APPLICATION NO.	FILING DATE	FIRST NAMED INVENTOR	ATTORNEY DOCKET NO.	CONFIRMATION NO.
10/085,649	02/26/2002	Andrew J. Whitton	091395-9214 (4596-TC-AU)	8642

Office Action Summary

DETAILED ACTION

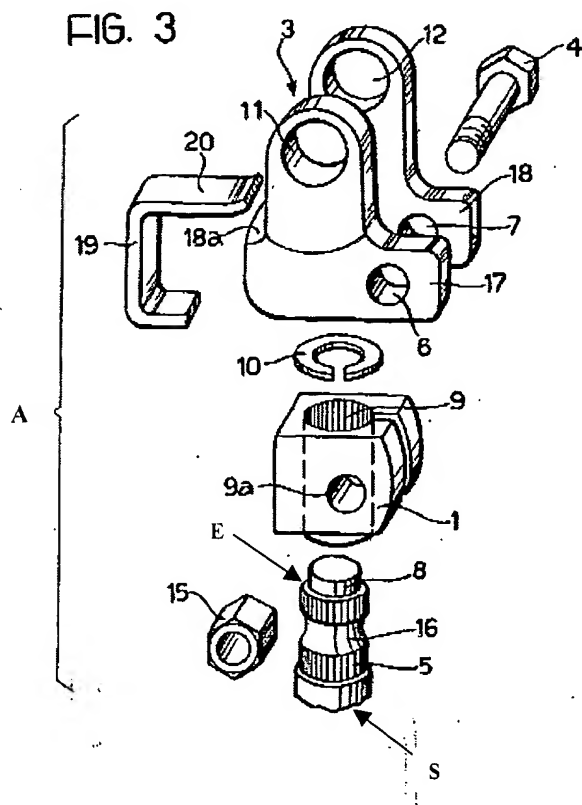
a. Claim 1. Pinna clearly discloses a shaft **S** configured for interconnection with a coupling element **1**, the shaft **S** comprising an axial shaft body **5** having upper and lower surfaces and terminating in a forward end **E**; a bolt receiving recess **16** in the upper shaft surface adjacent the forward shaft end **E**; and at least one projection **8** extending from the shaft forward end **E** adjacent the shaft upper surface (see annotated figure 3 below;).

- b. Claim 2. Pinna further shows the shaft body **5** having a given cross-sectional area and the projection **8** having a cross-sectional area substantially less than the [shaft body **5**] cross-sectional area (see annotated figure 3 above).
- c. Claim 8. Pinna also shows the bolt receiving recess **16** is an annular groove (see annotated figure 3 above).

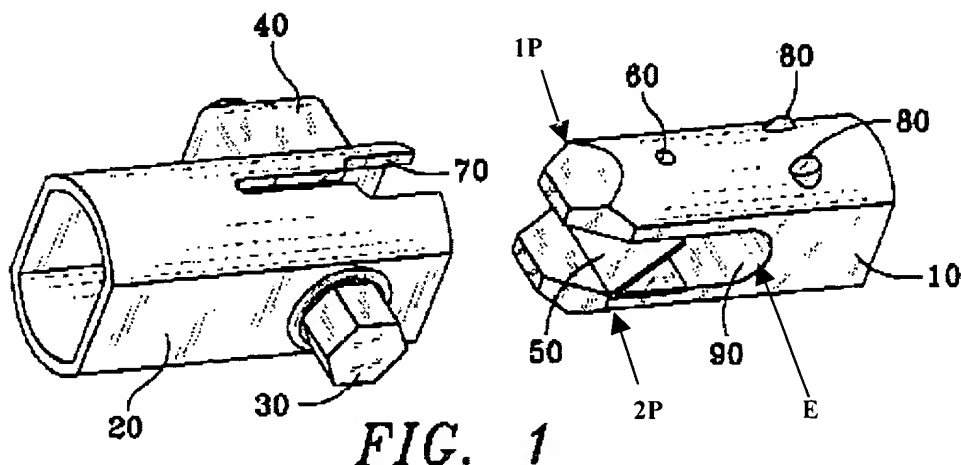
a. Claim 4. Pinna, as applied to claim 1 above, discloses a projection **8** extending from the shaft forward end adjacent the shaft lower surface, but fails to disclose a second projection substantially opposed to the projection **8** extending adjacent the shaft upper surface with an open space defined therebetween. Wey, however, teaches a second projection **2P** extending from a shaft forward end adjacent a shaft lower surface, the second projection **2P** substantially opposed to the projection **1P** extending adjacent the shaft upper surface with an open space **90** defined therebetween to provide flexible prongs (see annotated figure 1 below). Therefore, it would have been obvious to one having ordinary skill in the art at the time the invention was made to modify the projection of Pinna to include a second projection opposed to the first projection with an open space therebetween as taught by Wey.

c. Claim 6. The combination of Pinna and Wey, as applied to claim 4 above, includes a shaft body **5** having a given cross-sectional area and the first **1P** and second **2P** projections having a cross-sectional area substantially less than the [shaft body **5**] cross-sectional area (see Pinna annotated figure 3 above and Wey annotated figure 1 above; see also subparagraph 6(b) above).
